**City of Kingston
Report to Heritage Kingston
Report Number HK-21-045**

To: Chair and Members of the Heritage Kingston
From: Paige Agnew, Commissioner, Community Services
Resource Staff: Jennifer Campbell, Director, Heritage Services
Date of Meeting: October 20, 2021
Subject: Application for Ontario Heritage Act Approval
Address: 35 Brock Street P18-073
File Number: File Number P18-045-2021

35 Brock Street, Kingston ON
Casa Domenico Restaurant and Apartments
Heritage Submittal

Figure 1. Drawing showing new roof plan with existing parapet to be removed highlighted.

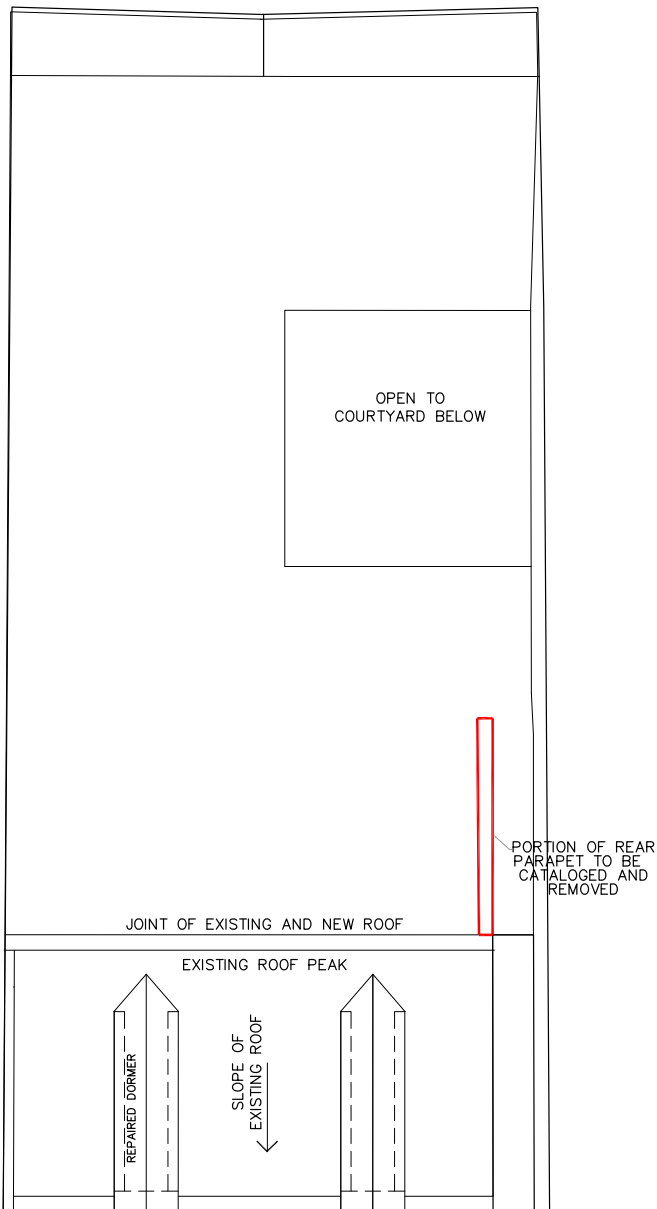
3. Related to the above – how does the flat roof of the addition connect to the existing parapet walls? Does it extend east-west and attach to them? How will the parapet walls be protected/detailed? Drawings illustrating this interface are required.
There is only one existing parapet wall in the rear of the building, it will be removed and usable stone will be used as feature elements in the interior of the building. The current height of the parapet wall will not meet the new roof (fig. 1, 2 & 3), and the change will not be visible from street level. This is necessary to make the apartments and structure function.

Figure 2. Shows no parapet on rear slope of existing roof on west wall.

Figure 3. Shows rear portion of parapet that will be covered by addition.

Figure 5. Drawing showing new roof attaching to existing roof, and the required minimum head room on the third floor.

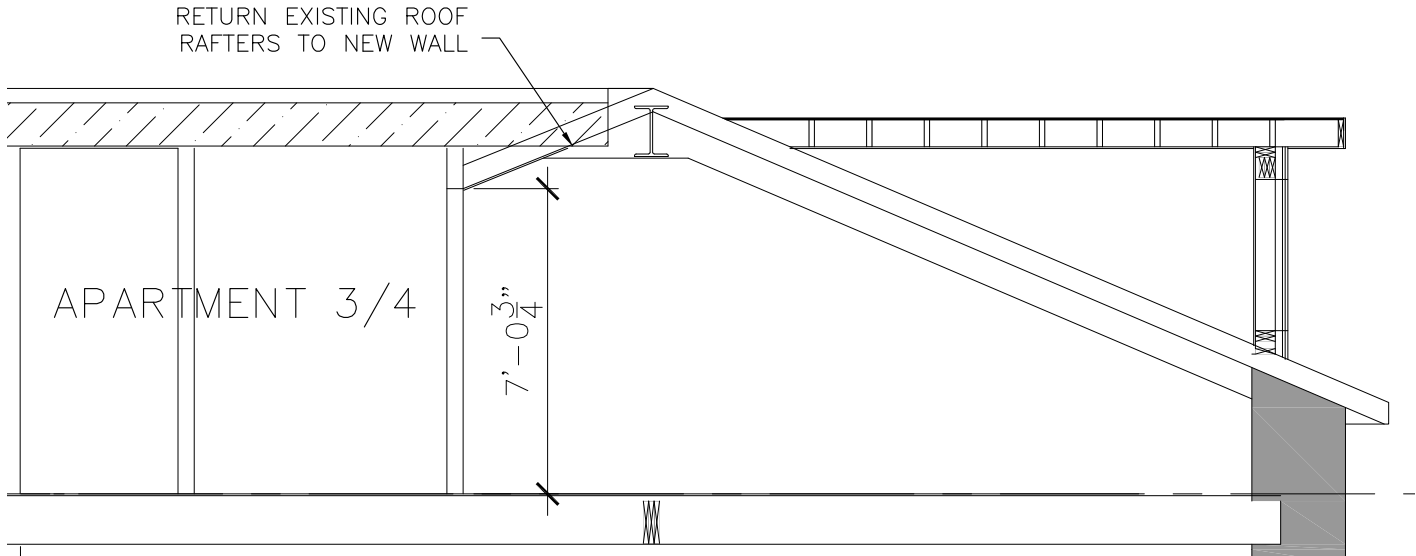
mentioned, the roof addition appears to be coming directly off the peak. Appreciating that you are working with minimum ceiling heights for the residential units, it would be preferable and follow best practice, and I am confident that Heritage Kingston members will also comment, that the new flat roof addition should be stepped down from the peak. The existing conceptual drawings do not provide a clear understanding of how and at what height the flat roof addition connects to the existing gable roof.

To achieve a ceiling height acceptable by the OBC it is necessary to have the new roof meet the existing roof a few inches below the peak (fig. 5).

Figure 6. Drawing showing new roof plan with location of infill wall highlighted.

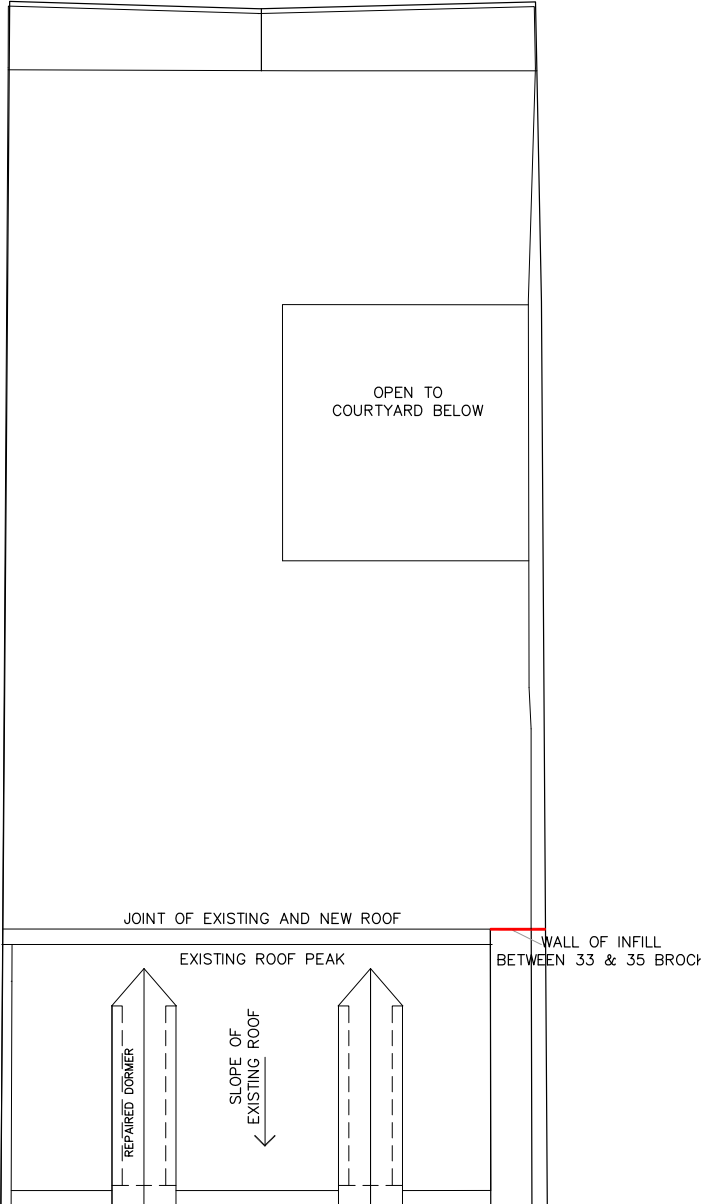
9. Are you proposing a gable roof structure over the infill between 35 and 33 Brock? If so, can you explain the rationale behind this and confirm that roof structure will be set below the existing parapet walls? Or will the third floor addition be visible from the street? We need a drawing that adequately illustrates this detail/interface.
